## &lt;Addendum #2&gt;

**Date: August 29, 2012**

**PROJECT #: EL-0006-C01**

**DESCRIPTION: Elizabeth Academic High School**

Copyright, Skidmore, Owings & Merrill Architects, LLP 2009  
DATE: JULY 13, 12  
SHEET NO: S-106B

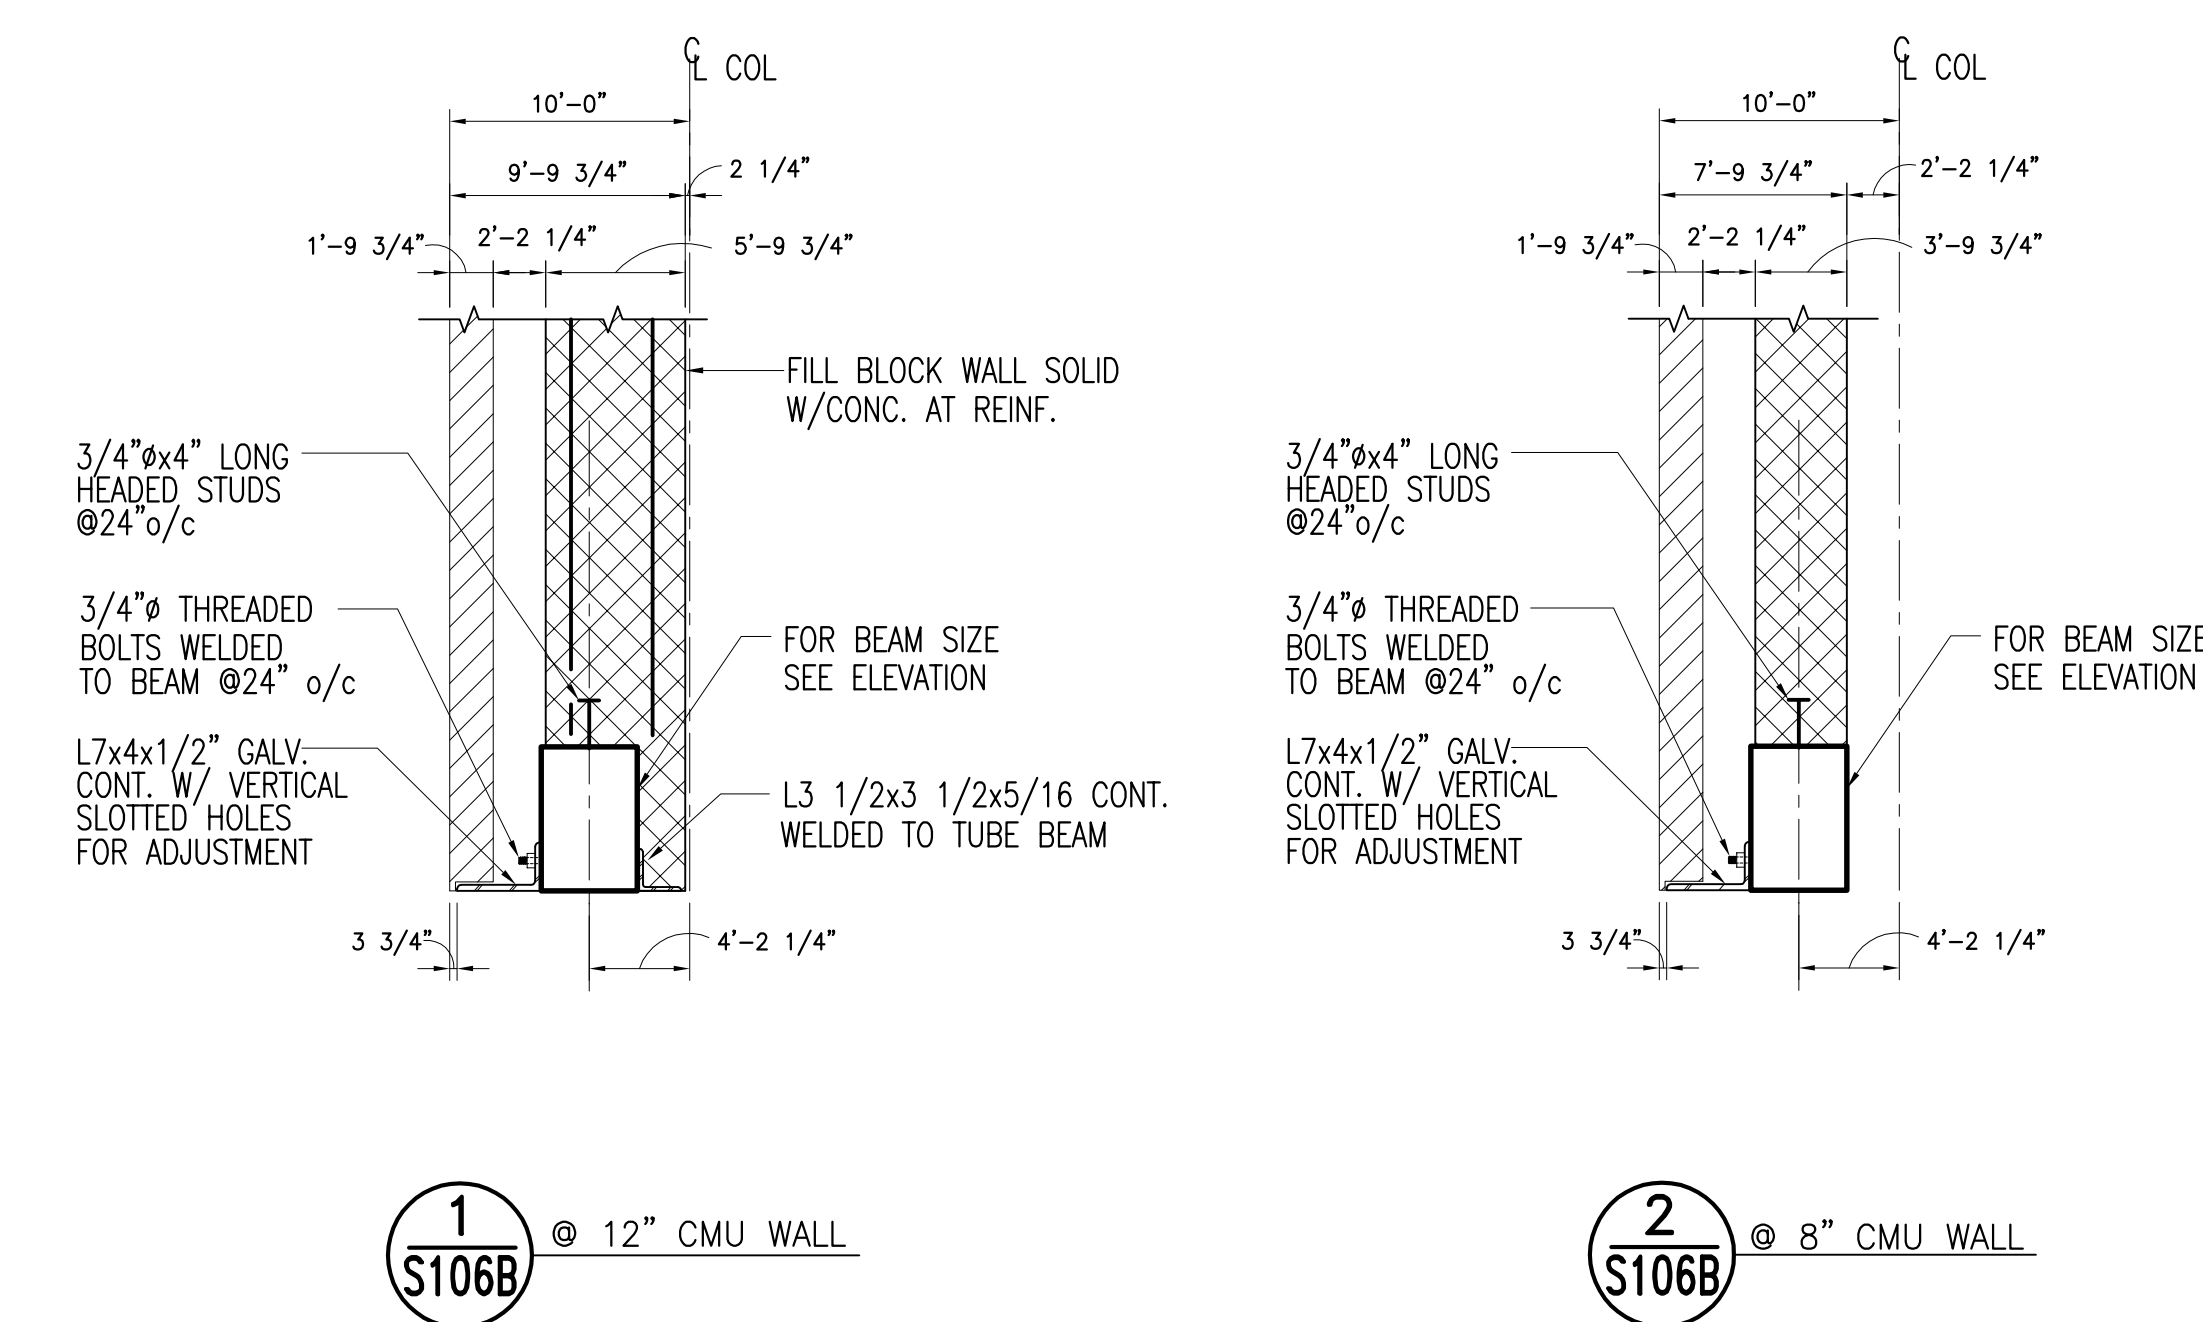
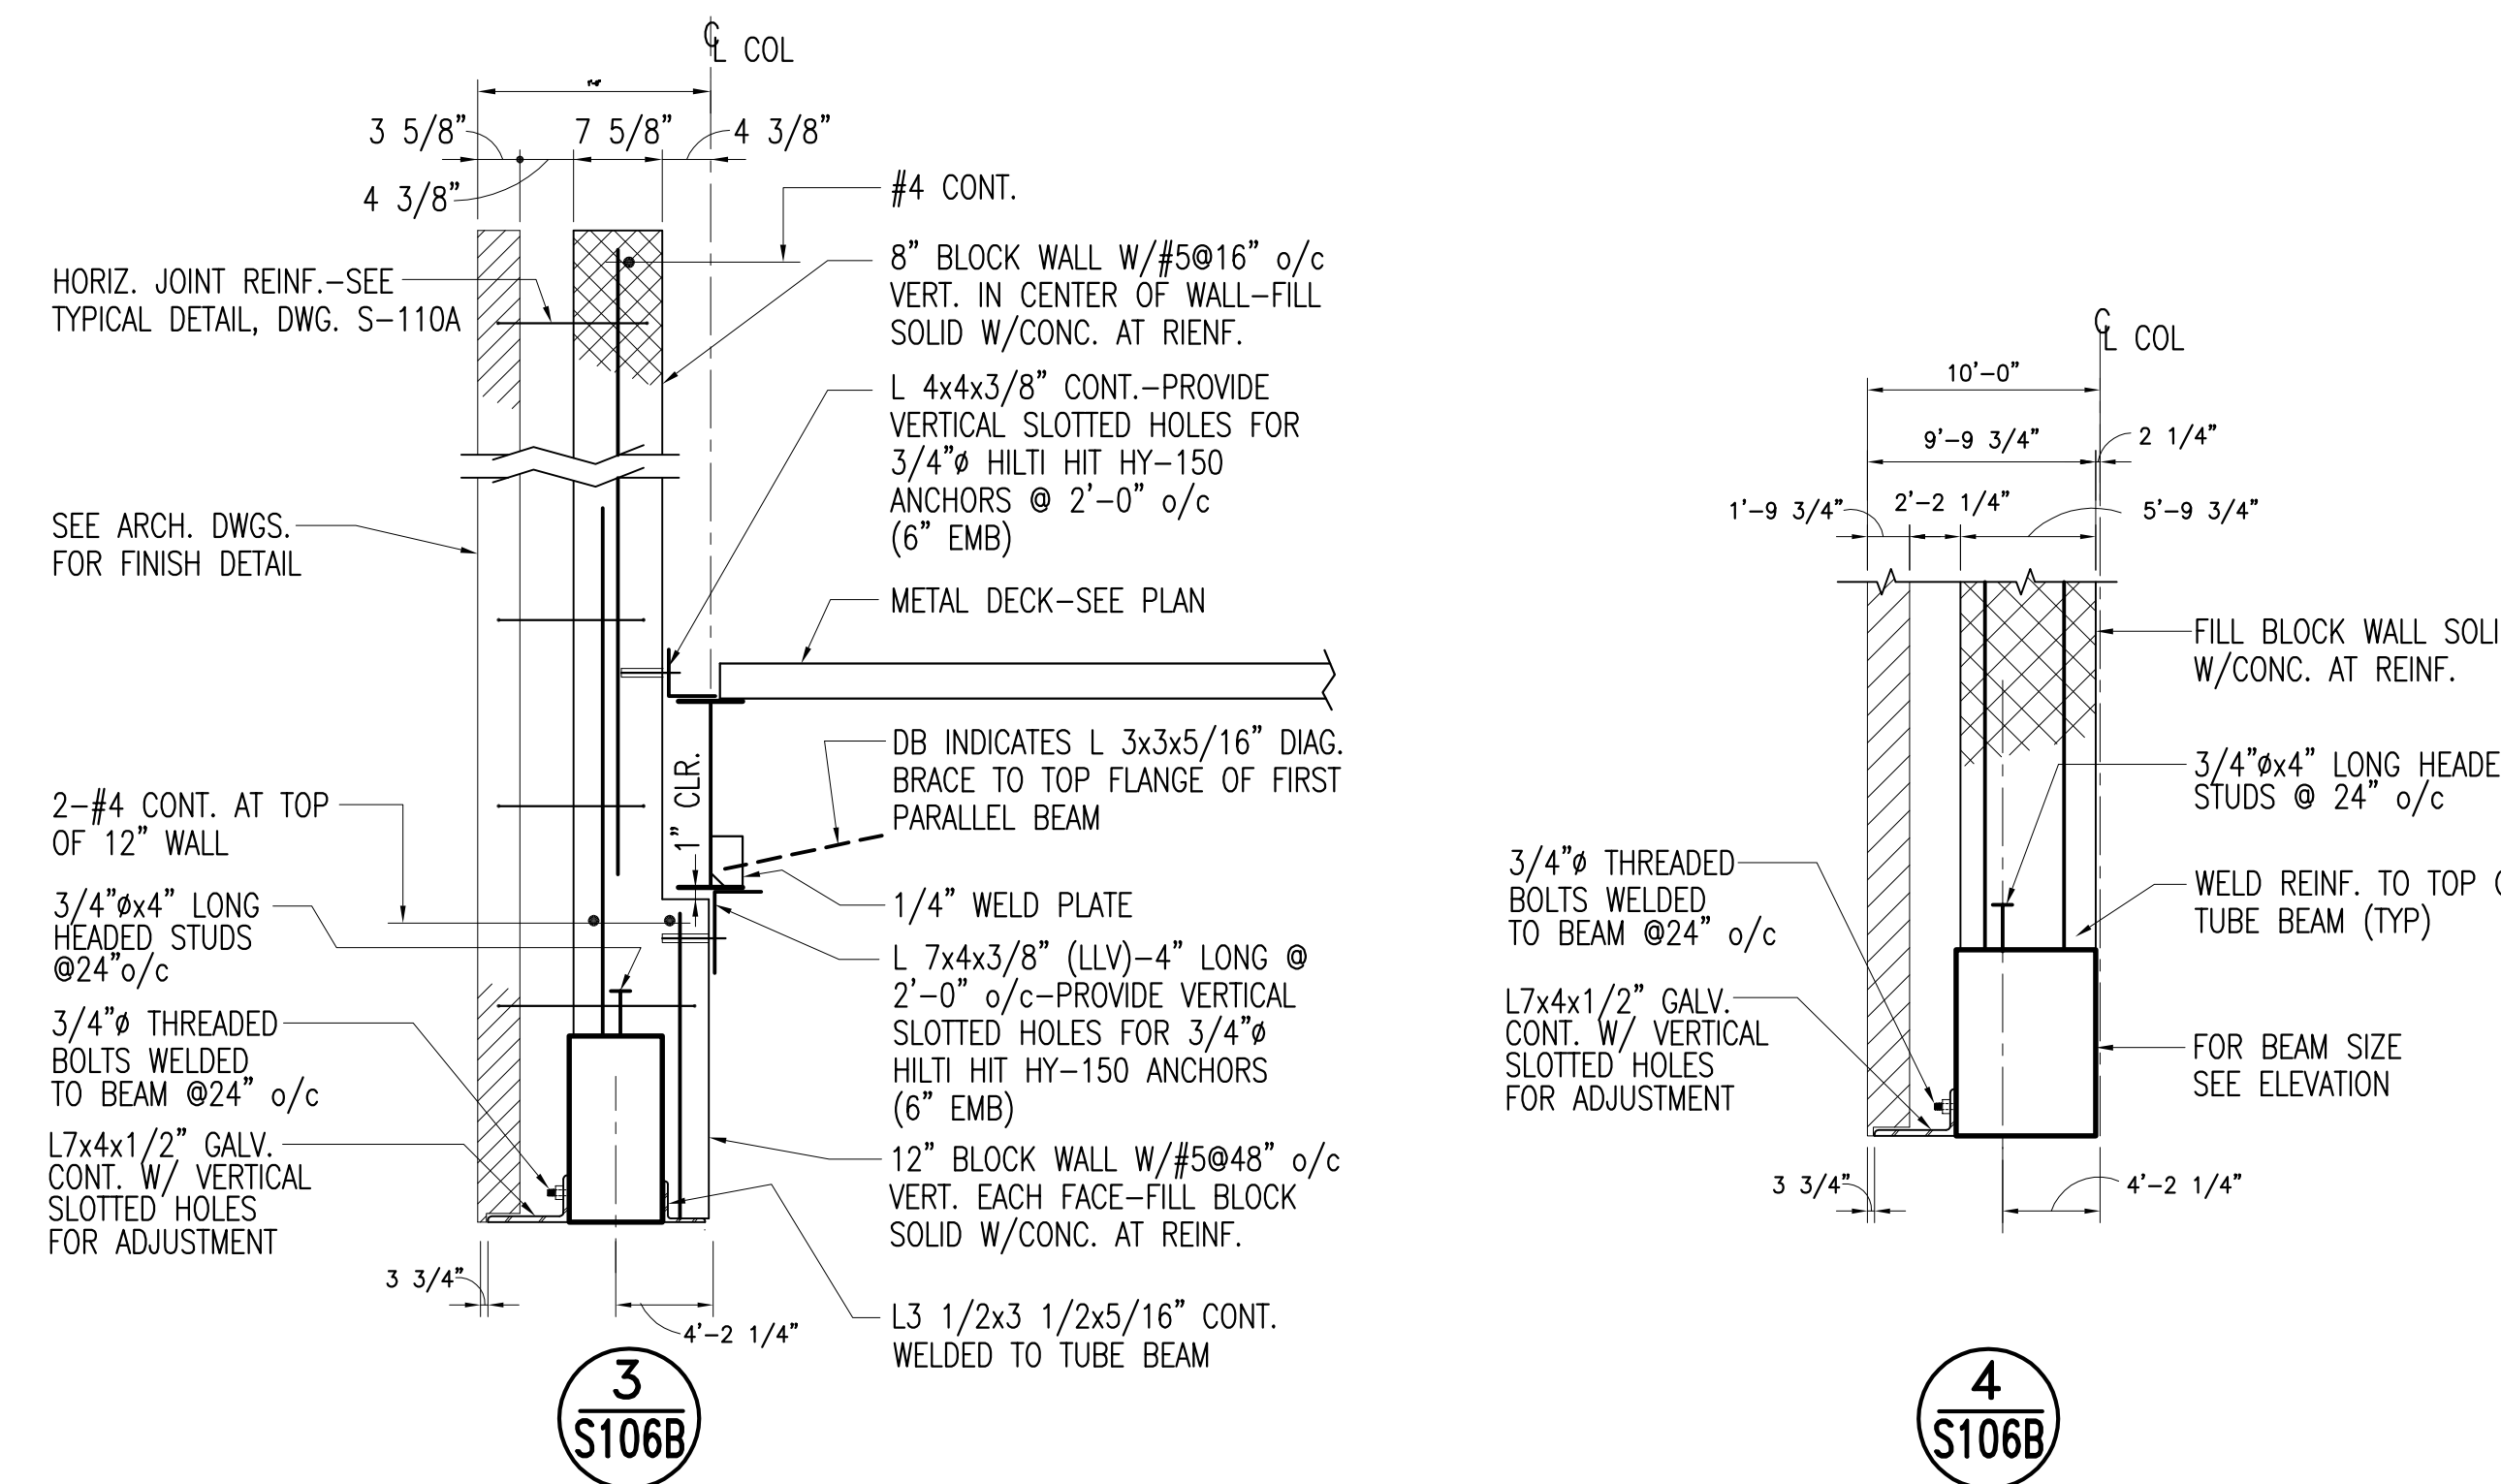
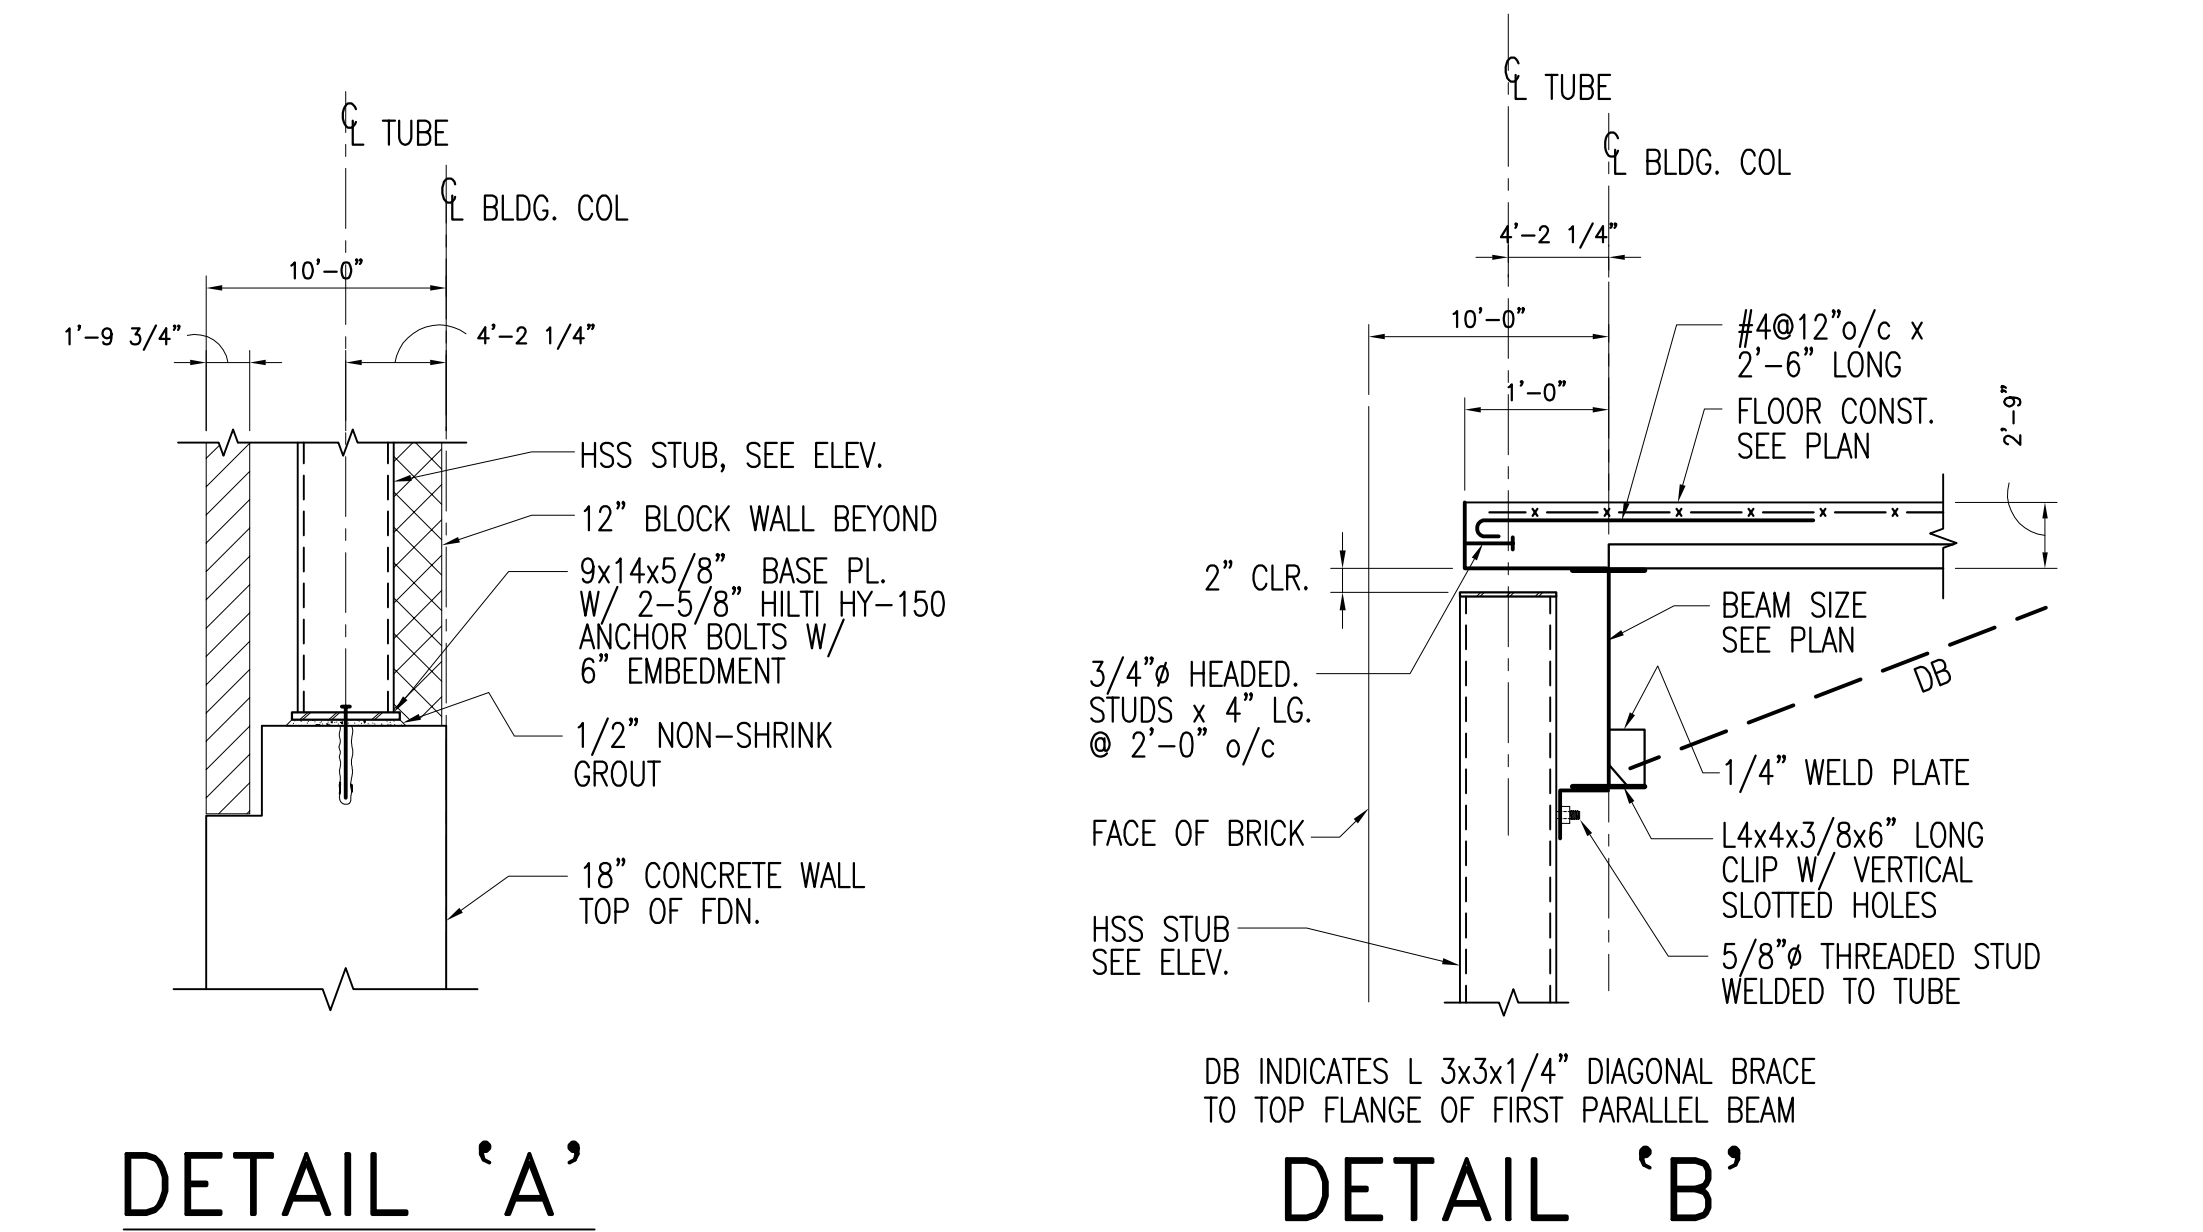
**A.20 Question:** Drawing S-106B Details 1 -4 and A – D dimensions are very small and unreadable. Please reissue in larger font.

### **B.4**   **Drawing S-106B**

Attachment #5 – Revised Drawing S-106B with more legible dimensions on details, in response to Question A.20.

**Answer:** See revised Drawing S-106B (Attachment #5).
